Our Case Number: ABP-317767-23

Re: Proposed construction of 39 residential units, widening of Pausdeen Bridge and all associated site works.  
Newtown/Ardclough Road, Newtown, Celbridge, Co. Kildare.

## Planning Observation Submissions to An Bord Pleanála

## Planning Observation Submissions to An Bord Pleanála - Updated 260923 Rev 2

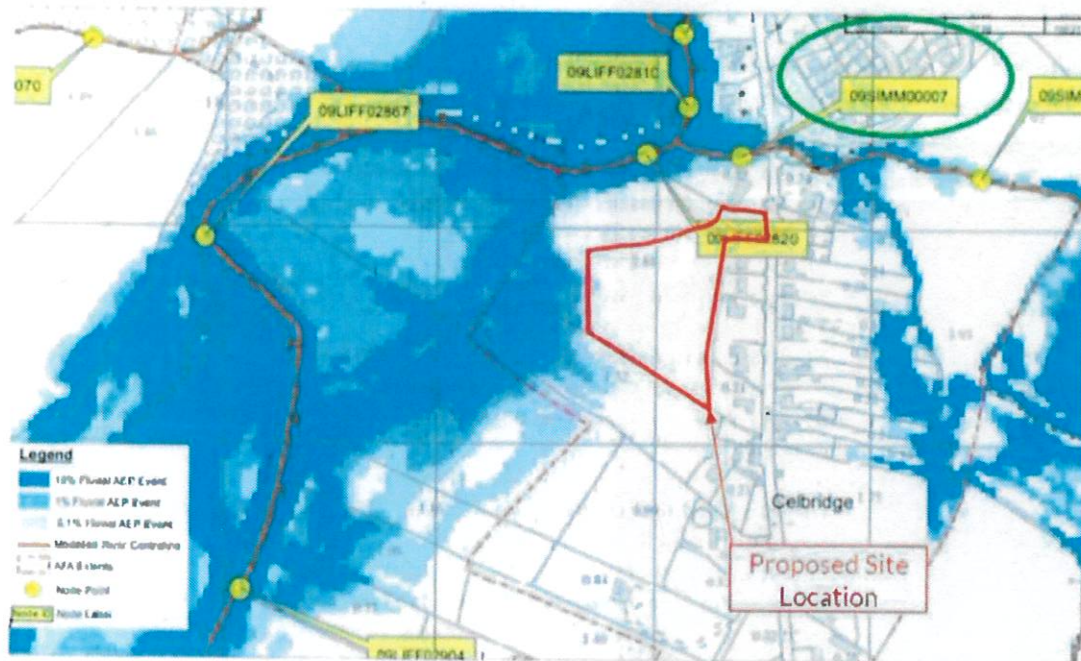
*I have circled Chelmsford in green. The properties in the proposed site will not be able to obtain home insurance with flood cover included."*

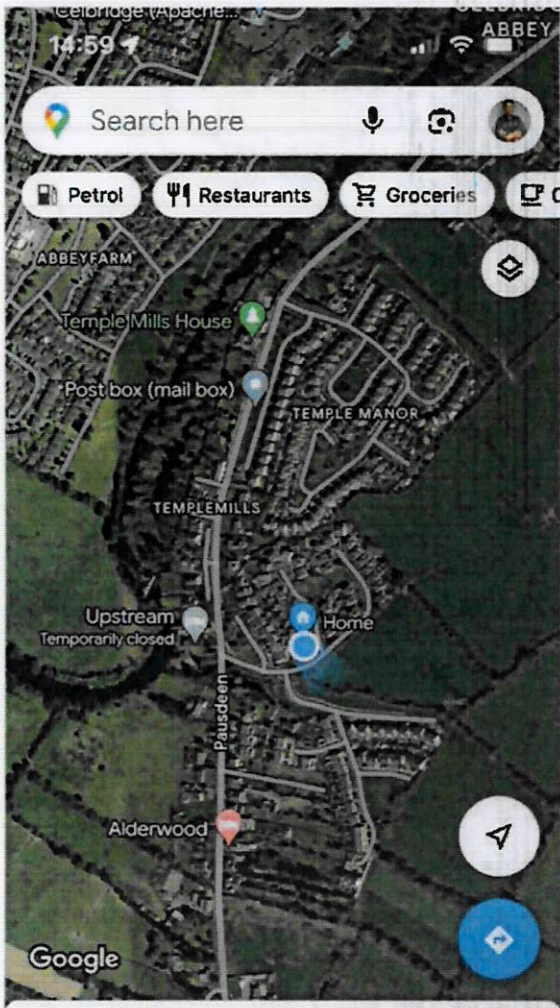
The diagram below shows that the site boundary (40m from river) would be the closest development to the flood plain on the west side of the Ardclough Road. No other development is as close to the Liffey flood zone on the southern side of the river.

New proposed pedestrian crossing

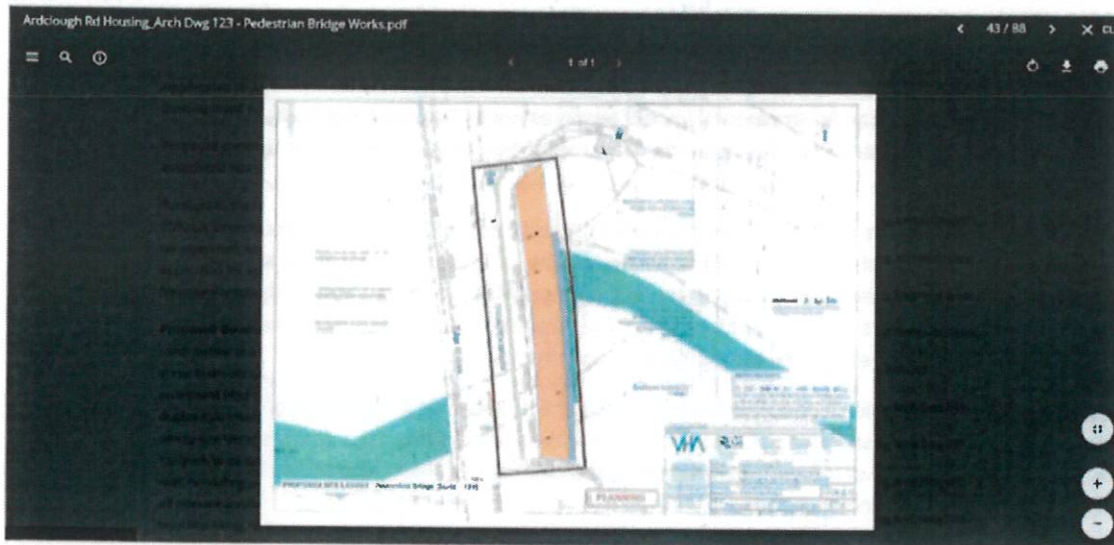
**The information in the Bruton Consulting Engineering Report or KCC Planning Application Report does not consider the ownership of the Common Green Areas at Entrance along with the two Pillars at the entrance to Chelmsford. The lands are not owned by the County Council, and they will need permission from the owner to carry out any works on this proposed site.**

**Resolution: The Chelmsford Residents Association should be given documented evidence that permission from the owner that any works on the planning application for bridge widening and new proposed zebra crossing has been given.**

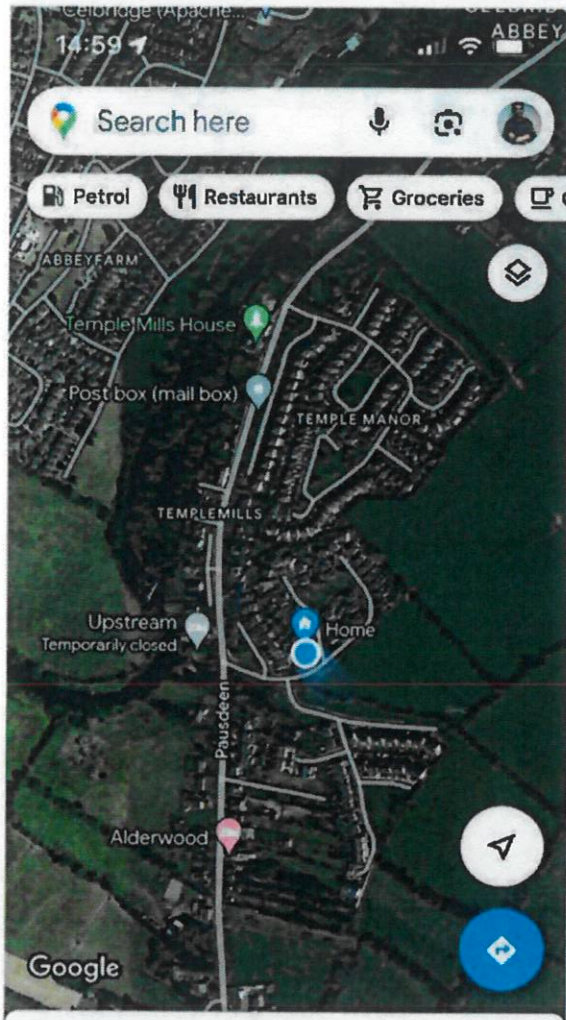
The diagram below shows that the site boundary (40m from river) would be the closest development to the flood plain on the west side of the Ardclough Road. No other development is as close to the Liffey flood zone on the southern side of the river.
